# UNITED STATES PATENT AND TRADEMARK OFFICE

# Office Action Summary

10/587,244

### **DETAILED ACTION**

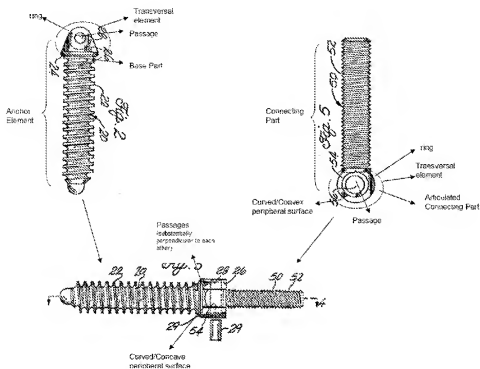
Regarding **Claim 1**, Howland discloses a vertebral osteosynthesis device (see Col 3 lines 4-14 and see Figs below), comprising bone anchoring elements, intended to be connected to said anchoring elements and to be fixed to the vertebrae by means thereof, and connection means (#12) of rod (#16) to said anchoring elements, at least one of said anchoring elements being of the "polyaxial" type comprising an articulated connecting part with respect to the base part, said connecting part and said base part each comprise a transversal passage and a rigid transversal part which direction is substantially perpendicular to the direction of said passage, said rigid transversal part of the connecting part or of the base part being inserted in the transversal passage of the

base part or of the connecting part, and vice versa, in such a way that these rigid transversal elements are pivotable in these passages (see Col 3 lines 4-14 and see Figs below).

Regarding **Claim 2**, Howland discloses characterized in that said transversal rigid transversal element of the connecting part or of the base part are made by providing a ring on the connecting part and a ring on the base part the two rings of the connecting part and the base part being inserted into each other similarly to links in a chain (see Col 3 lines 4-14 and see Figs above).

Regarding **Claims 3, 11** Howland discloses that each rigid transversal element comprises a rounded contact surface with the other rigid transversal element, the radius of curvature of said contact surface being greater than the radius of the cross-

section of the other rigid transversal element (see Col 3 lines 4-14 and see Figs above, where the rounded surface of the transversal element of the connecting part contacts the rounded surface of the transversal element of the base part).

Regarding **Claims 9-10**, Howland discloses the connecting part comprises a curved bearing surface, suitable for resting against a corresponding curved bearing surface of said base part and sliding against said surface during movements of said connecting part with respect to said base part, wherein the connecting part comprises a convex peripheral surface, in the form of a spherical cap, and said base part comprises a corresponding concave peripheral surface (see fig above)
